REZONING: CONDITIONAL REZONING - SOUTHGATE APARTMENTS (P21-62-CZD)

CITY OF HENDERSONVILLE - COMMUNITY DEVELOPMENT STAFF REPORT

View of delivery truck preparing to back in to loading dock at shopping center utilizing proposed driveway to subject property

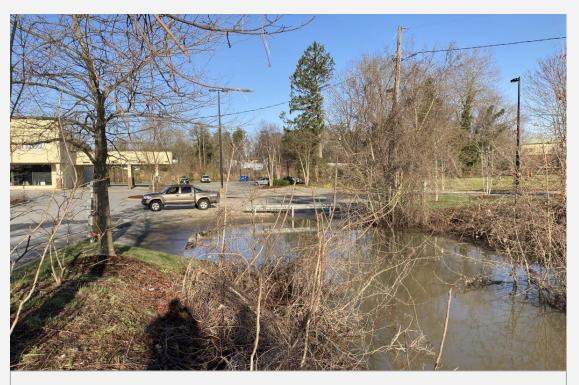
In addition to the requested technical revisions to the report, recommendations related to addressing conflicts with delivery trucks entering the entrance area of the site have been provided to the applicant. The delivery schedule for Southgate is as follows:

- PetSmart (large trucks): Deliveries 2X/week, Mon. and Fri. between 7am-Ipm
- Fresh Market (smaller trucks): Deliveries daily Mon-Sat between 6am-3pm

- Revise TIA accordingly
- Revise site plan to accommodate recommended Alternative for entrance / loading dock access.
